MEETING NOTICE – SITE REVIEW COMMITTEE

RE: Founders Terrace, HB-524-2; New 11,873 Square Foot Commercial Building

ISSUE: Discussion and action on a new 11,873 square foot commercial building and associated site improvements

RE: Wash Shack Site Plan Application

BUILDING ELEVATION - NORTH

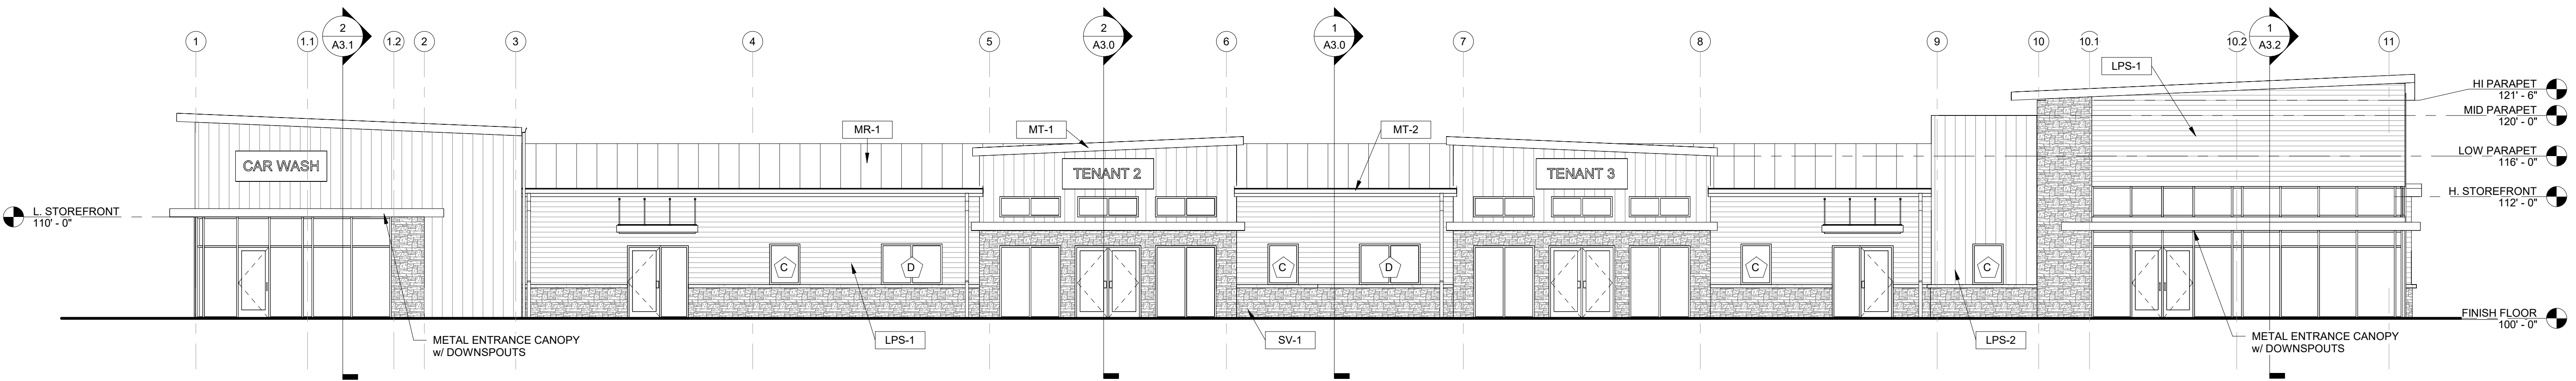
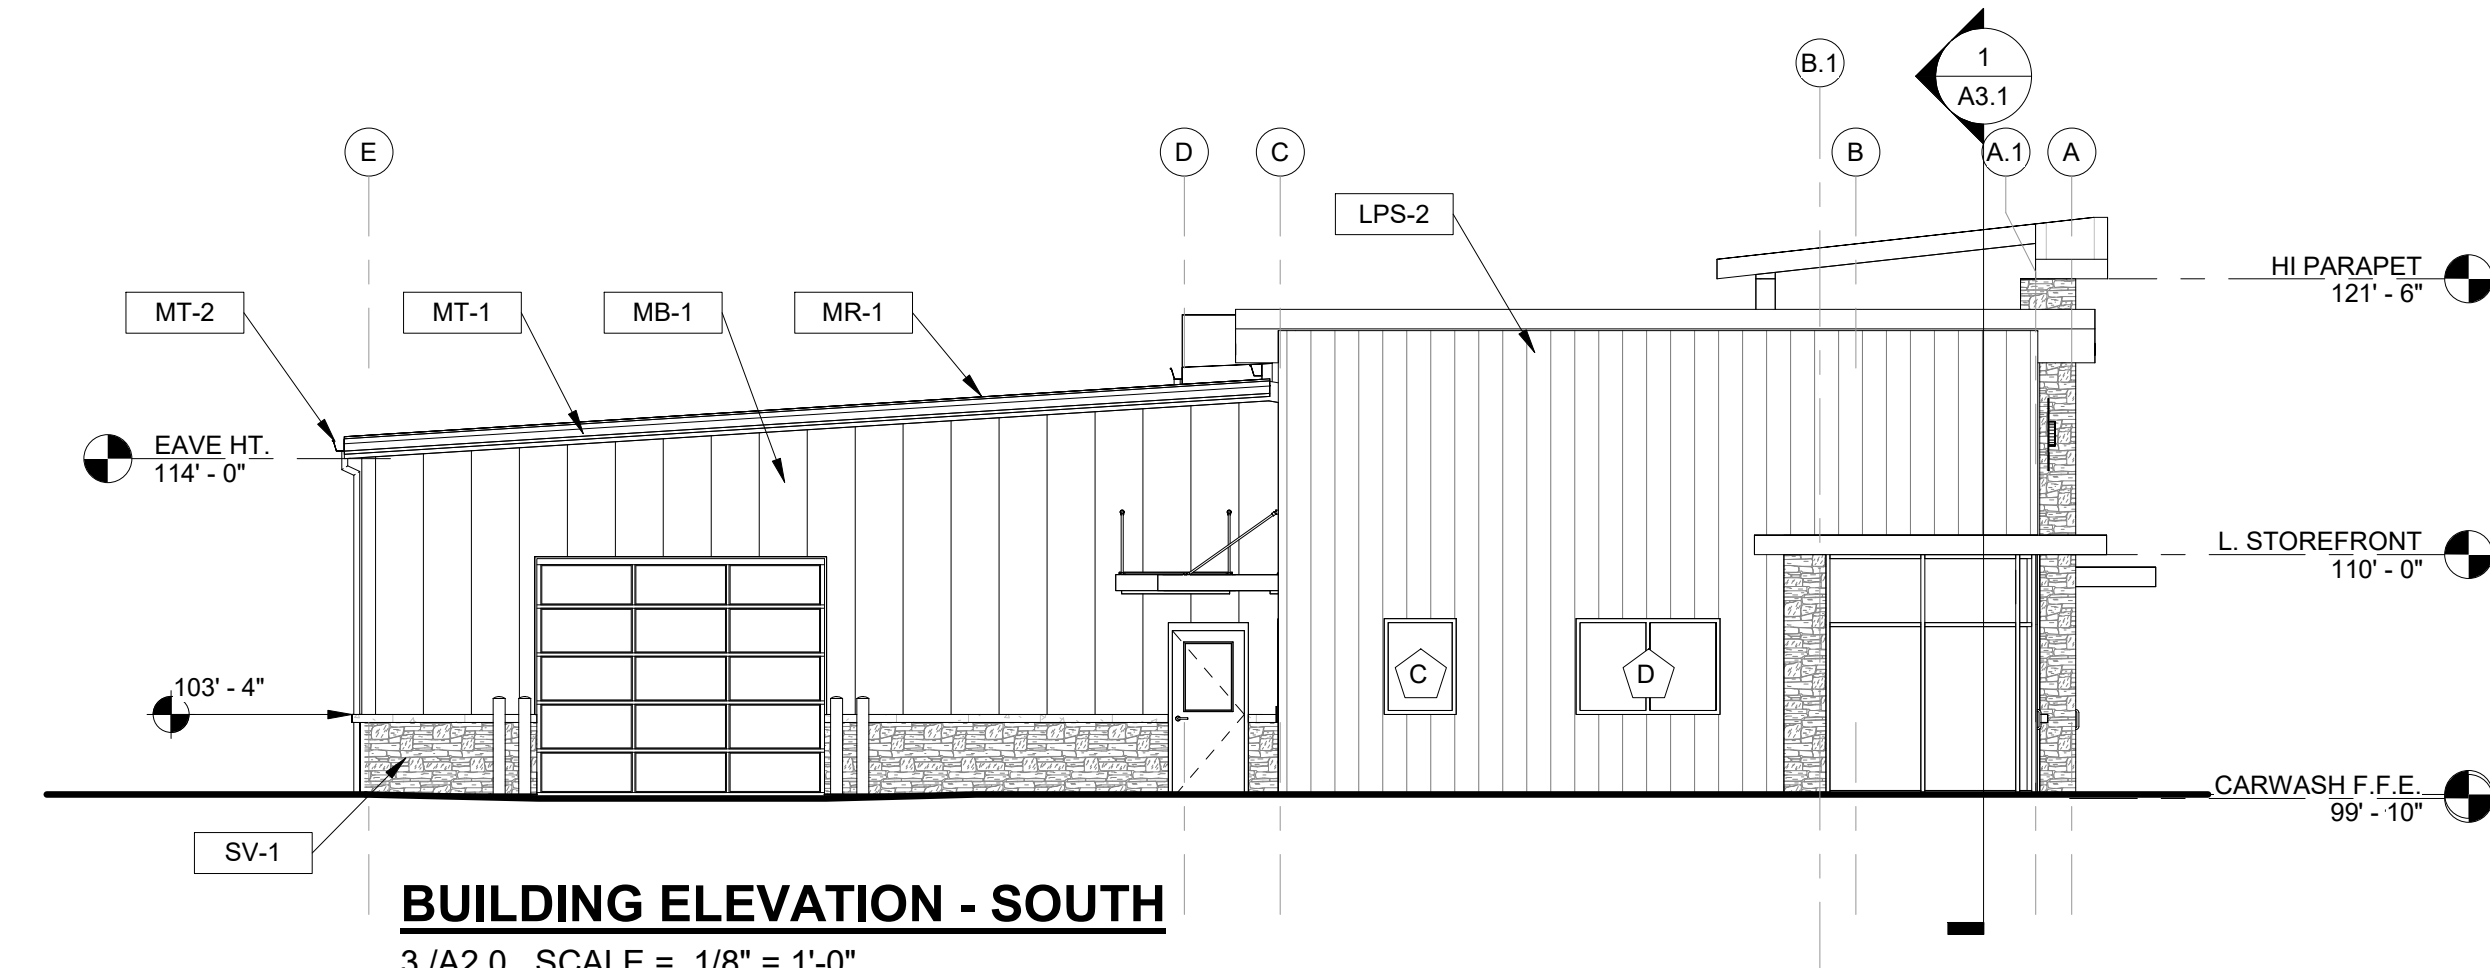
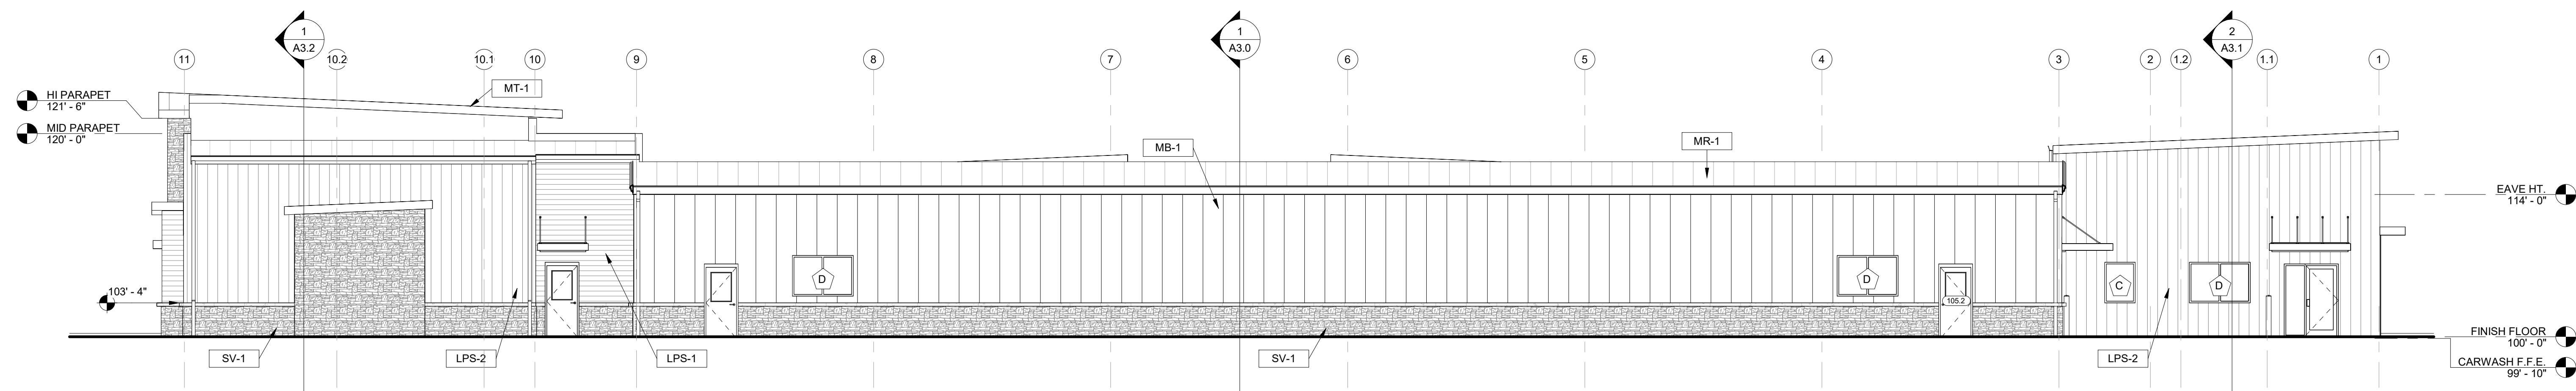
Section 5, Signage: Wall signage is noted on the front (east) elevation for all four tenant spaces on the attached plans and Staff would recommend that the two end tenant units be approved to have wall signage for the side wall of their respective tenant spaces. Additionally, the applicant is requesting the construction of two monument signs to be located along Centerline Dr. with one detailing the access for the car wash driveway. Location may need to be modified depending on confirmation to be received from WPS on the 20’ easement. Staff would recommend approval for sign placements only at this time with a more detailed sign package being submitted for review and approval prior to installation. (west, south, and east) of the building along the office area.

5. Light Pole relocation will be by Village contractor reimbursed by developer
6. Wall signs to be located as noted on the submitted building elevation drawing in possibility to locate a second wall sign on the side walls (North and South elevations) of the two end tenant units. Signage details for all proposed signs on site shall be submitted for approval prior to installation
